Re: Turkey Point Units 3 and 4
Docket Nos. 50-250 and 50-251
Supplement to License Amendment Request 196 (ADAMS Accession No. ML092050112) - Summary of Turkey Point Sump pH Calculation Inputs, Assumptions, Methodology, and Results

LICENSE AMENDMENT REQUEST 196 SUMMARY OF SUMP pH CALCULATION INPUTS, ASSUMPTIONS, METHODOLOGY AND RESULTS

NRC Questions 1 and 2

NAI-1396-046, Rev. 1, Turkey Point Units 3 & 4 Post-LOCA Sump pH Report

Figure 3: Case 1 sump pH profile

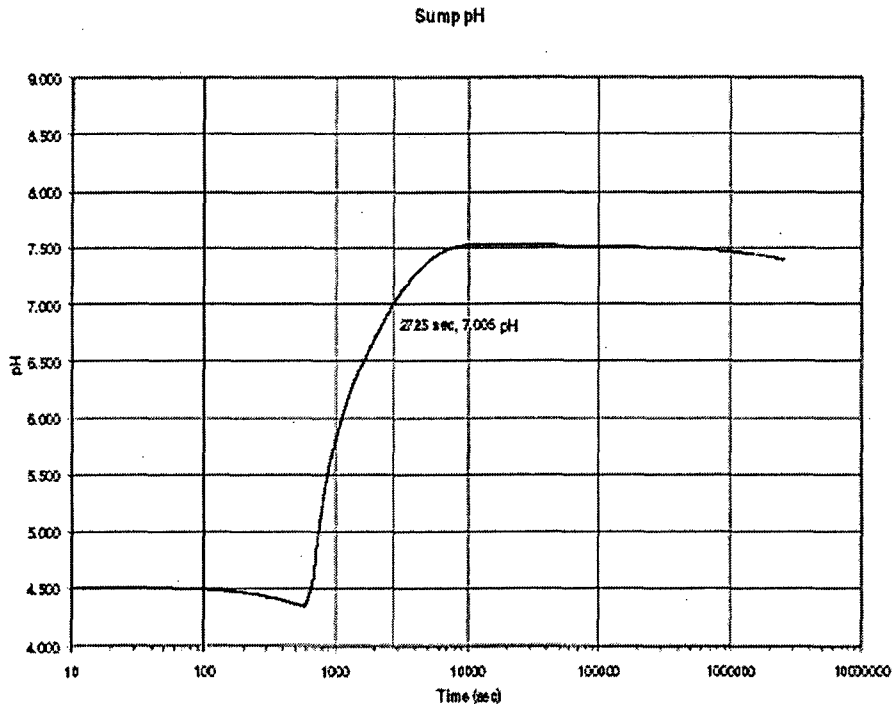
1. *Provide time dependant values of strong acid concentrations in the sump for a period of 30 days after a loss of coolant accident (LOCA).*
2. *Describe the analysis methodology used, including assumptions and inputs, to determine the pH in the sump water during a period of 30 days post-LOCA. Include detailed calculations of time dependant pH values in the sump during a 30-day period post-LOCA to demonstrate that the pH remains greater than 7 throughout this time period.*

The time-dependent pH profile for Cases 1 and 2 are shown in Figure 3 and Figure 4, respectively. The corresponding minimum long-term pH varies between 7.241 and 7.396 for these cases. Each of these figures shows the sump pH initially decreasing due to hydrochloric and nitric acid generation. The pH increases quickly once the water level reaches the bottom of the baskets and begins dissolving the borax. The peak sump pH is reached once all of the borax is dissolved and then begins declining due to continued acid generation. Table 2 summarizes the inputs and results for these cases.
